Waterbeach New Town Supplementary Planning Document (SPD)

Statement of Consultation

Summary tables of main issues raised, Council assessment and proposed modifications

Fig. 19 | Access Movement and Connectivity

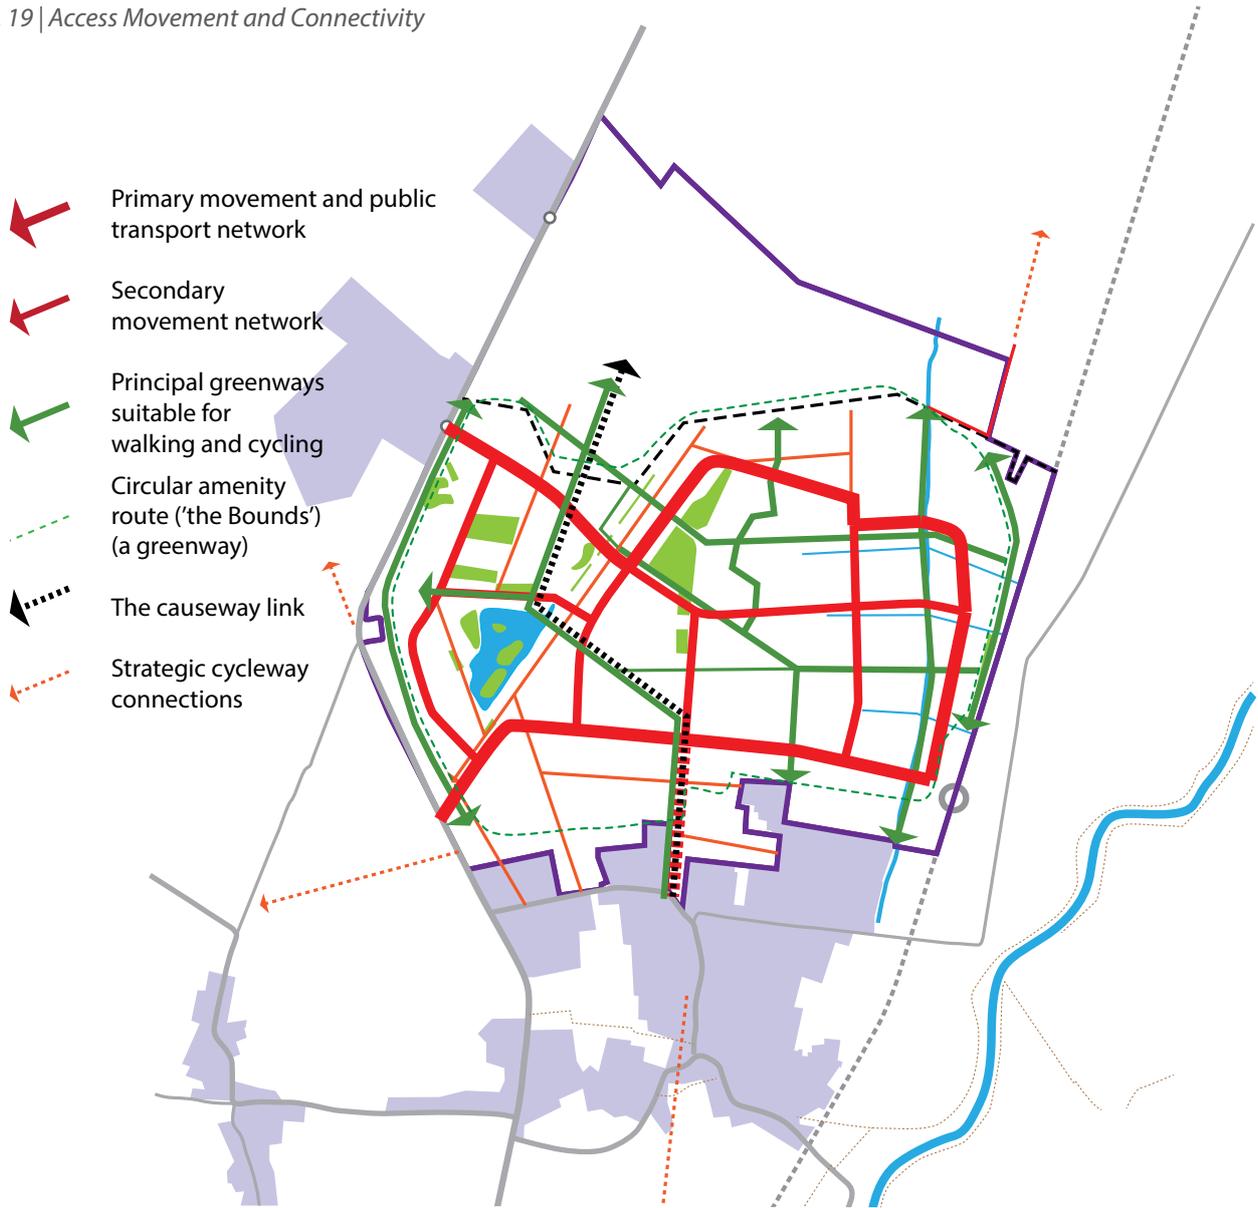
<p>town, particularly railway station. Figure 19 should be strengthened to enable cross town cycle and pedestrian movements over and above cross town vehicle movements. Potential for perimeter vehicle route around town, with each residential area to be self contained and only accessible by vehicle from perimeter road. Potential to favour cross town walking and cycling links by limiting cross town vehicle movements between residential areas. Similar to Cambridge Core Traffic Scheme which limits ability for cross town vehicle movement. Layout and primary road plan should be amended to allow for perimeter road, and with secondary roads serving self contained residential areas only.</p> <ul style="list-style-type: none"> • No need for town centre car parking as it will encourage car use; Access to station should be from A10 not Cody Road; Conflict between main routes through town and functionality of town, which should be kept free of traffic and air quality impacts; Support northern park and ride to relieve A10 to south and for visitors to town / station. No need for park and ride at station; Welcome Causeway link - historic and creates symbolic and actual link between village and new community. • Fundamentally, no clear vision to truly embrace this new town as an opportunity for developing a sustainable modern town with excellent public transport infrastructure. Traffic to new station is routed through old village, past primary school, GP surgery, and nursery. • Primary movement network shows highly interconnected road network for cars, with routes bisecting new town. Encourages car use for journeys within development, with direct routes between destinations. Will bring external traffic through middle of development. Primary routes should be taken around edge, with radial connections linking sectors of development. Connections through middle of site should be limited to pedestrians, cyclists and public transport. All pedestrian and cycle routes should be designed with strong natural surveillance to bolster personal security". Need strategic walking and cycling route to Chittering. Object to dwellings using new vehicular access road serving relocated station. Cycle and pedestrian routes must be afforded same importance as primary/secondary road links. Land use budget does not include land for pedestrian/cycle paths off road. Important that connections across land ownership for cycle and pedestrian routes are agreed within SPD. Sustainable modes of travel should be phased before first occupation. WCC propose additional items to be added to Table 8. • Segregated access to village utilizing Cody Road should not be accessible from new development by private vehicle, to avoid it becoming rat run. Taxi and bus and emergency services may have access. Car parking from new development should be limited with ample cycle parking and linking bus routes to facilitate public

Agree that the Greenways shown on Figure 19 would be easier to locate if shown in green rather than red to avoid confusion with the road designations.

<p>Proposed Modifications</p>	<p>Page 42: <u>'Education'</u> line 2 – add the words 'in time to meet evidence of need' after the word 'facilities'.</p> <p>Figure 24 page 54 <u>'Greenways and corridors'</u> – Amend to ensure that the Fen edge / rail corridor edge marking does not extend over the new railway station and its close surrounds (to be consistent with the spatial framework diagram).</p> <p>Figure 19 <u>'Access movement and connectivity'</u> – Amend to show the principal greenways as green lines and not red at present.</p>

Fig. 21 | Primary movement and access framework plan (locations and alignment indicative only)

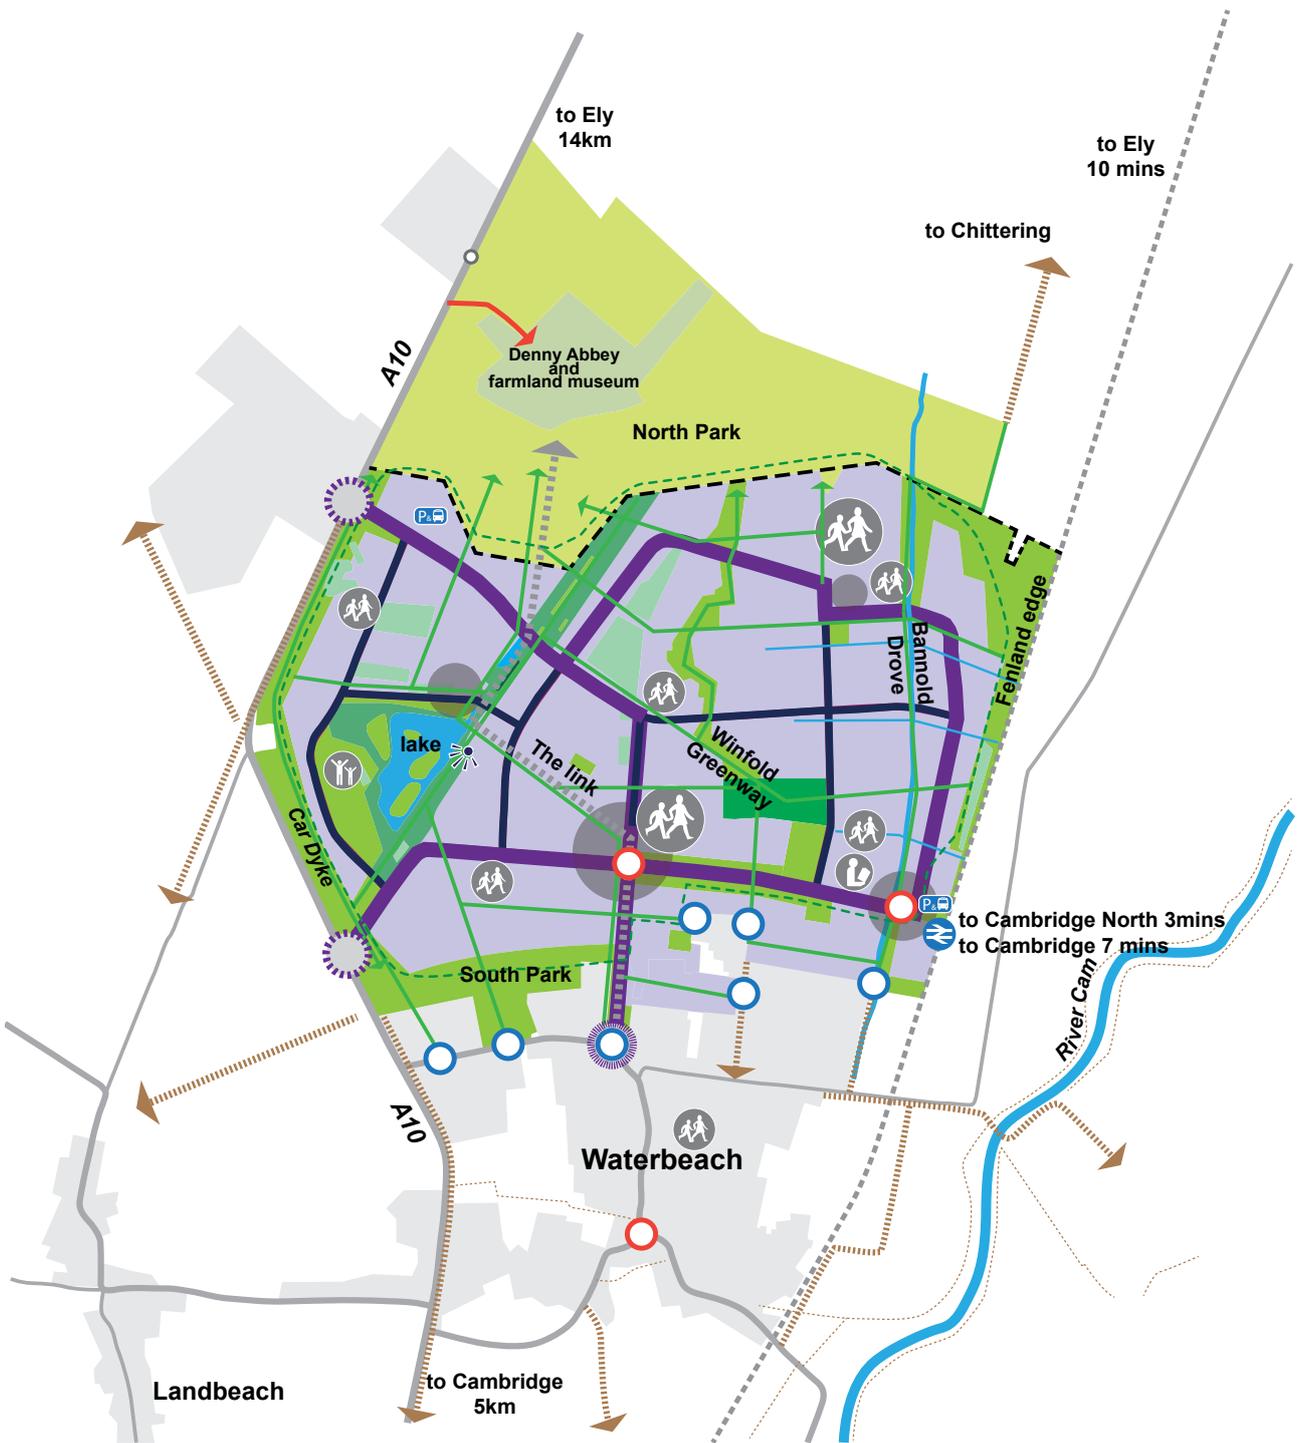
- * Figure 21 - causeway link annotation is confusing and does not match key on either p50 or 70.
 - * Concerns about yellow annotation of setting of Denny Abbey - could imply setting is limited to this area, when it is much wider. Figures 22 and 27 introduce different interpretations of setting.
